UNITED STATES PATENT AND TRADEMARK OFFICE

APPLICATION NO.	FILING DATE	FIRST NAMED INVENTOR	ATTORNEY DOCKET NO.	CONFIRMATION NO.
10/531,104	04/11/2005	Kimmo Laiho	006559.00008	2704
22907 7590 01/24/2008 BANNER & WITCOFF, LTD. 1100 13th STREET, N.W. SUITE 1200 WASHINGTON, DC 20005-4051			EXAMINER DANG, KHANH	
			ART UNIT 2111	PAPER NUMBER
			MAIL DATE 01/24/2008	DELIVERY MODE PAPER

Office Action Summary

DETAILED ACTION

Fig. 3

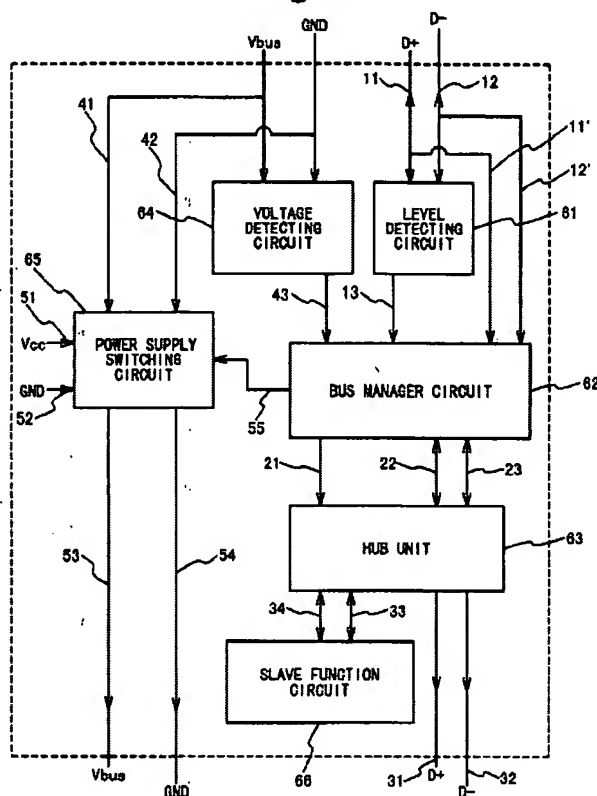
With regard to claim 1, Oguma discloses a device operable as a host device (as shown generally in Fig. 3, which is reproduced below for ease of convenience and reference, the portable device comprises a bus manager circuit can be operable as a host device)

comprising: a port connected to a bus (as shown in Fig. 3, USB port of the portable device provides connection to the USB bus comprising Vbus, GND), means for detecting the presence of another host connected to the bus and for relinquishing host status in response thereto (the voltage detecting circuit 64 is readable as the so-called "means for detecting." When the detecting circuit 64 detects presence of another host 1 connected to the USB bus, the host status of the portable device is relinquished. See at least column 2, lines 39-57, column 4, line 65 to column 6, line 17).
